Item ID: D350-607-541
Revision ID:
Item Name: AS350/AS355 Quick Release Heli-Utility-Basket™ Long, Heavy Duty Lid
Start Date: 5/1/2017 Start Qty: 1.00
Required Date: 5/11/2017 Req'd Qty: 1.00
Reference: SCHEDULED/C

DART SERVICE INSTRUCTION

TO AMEND INSTALLATION INSTRUCTIONS D350-607-3 Rev.D,
INSTALLATION INSTRUCTIONS D350-607-4 Rev. C AND
INSTRUCTIONS FOR CONTINUED AIRWORTHINESS ICA-D350-607 REV. 6
REF TCCA STC: SH94-14
REF FAA STC: SR00213NY
REF EASA STC: EASA.10016996
REF BRAZILIAN STC: 2007S03-03/-04/-05/-06

A	NEW ISSUE	AJS	14.05.16
REV.	DESCRIPTION	BY	DATE
DESIGN	AJS	DART AEROSPACE LTD HAWKESBURY, ONTARIO, CANADA	
DRAWN	AJS		
CHECKED		DRAWING NO.	REV. A
MFG. APPR.	N/A	DSI 9699	SHEET 1 OF 2
APPROVED		TITLE	SCALE
DE APPR.		LUG REPLACEMENT	NTS
DATE	14.05.16	COPYRIGHT © 2014 BY DART AEROSPACE LTD THIS DOCUMENT IS PRIVATE AND CONFIDENTIAL AND IS SUPPLIED ON THE EXPRESS CONDITION THAT IT IS NOT TO BE USED FOR ANY PURPOSE OR COPIED OR COMMUNICATED TO ANY OTHER PERSON WITHOUT WRITTEN PERMISSION FROM DART AEROSPACE LTD.

FIGURE 1: INSTALLATION OF D4775-041 FWD STRUT

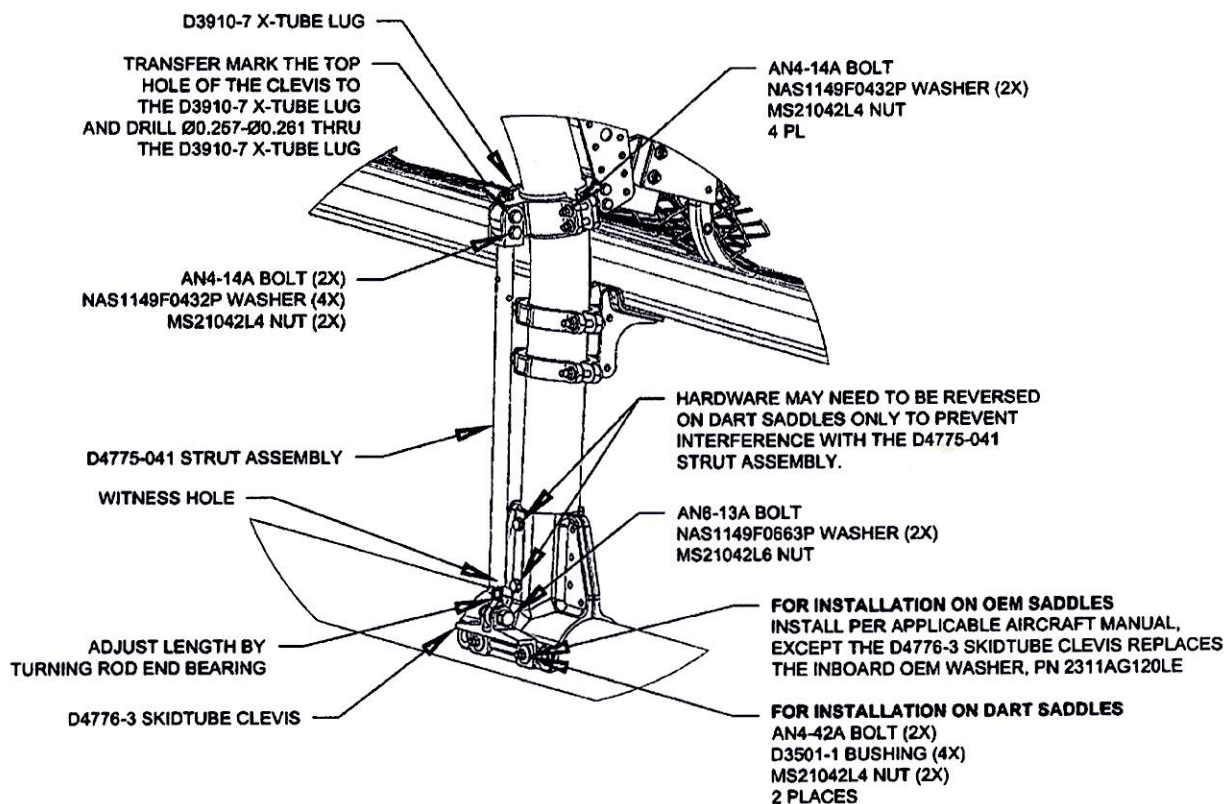
Modify the quantities for D3910-5 and add D3910-7 as follows:

- 3.1 Substitute the Forward Lower D3910-5 X-Tube Lug with the D3910-7 X-Tube Lug as shown in Figure 1.
- 3.2 Install the forward D4775-041 Strut Assembly. Transfer mark from the upper hole on the clevis of the D4775-041 Strut Assembly to the D3910-7 X-tube Lug and drill thru the lug $\varnothing 0.257\text{-}\varnothing 0.261$ as shown in Figure 1. Touch up chemical conversion coating per MIL-DTL-5541. Check the witness holes located at the bottom end of the D4775-041 Strut Assemblies to ensure that the thread from the rod end extends past the witness hole.
Torque MS21042L4/-4 nuts to 50-70 in-lbs (5.7-7.9 N-m). Torque MS21042L6/-6 nuts to 160-190 in-lbs (18.1-21.5 N-m).
- 3.3 Complete the installation in accordance with Installation Instructions D350-607-3 Rev. D or D350-607-4 Rev. C.

Install the D350-607-501 Conversion Kit, D350-607-511 Quick Release Mounting Kit or D350-607-431 Strut retrofit kit per Installation Instructions D350-607-3 Rev. D or D350-607-4 Rev. C. While installing the Forward Strut perform the following:
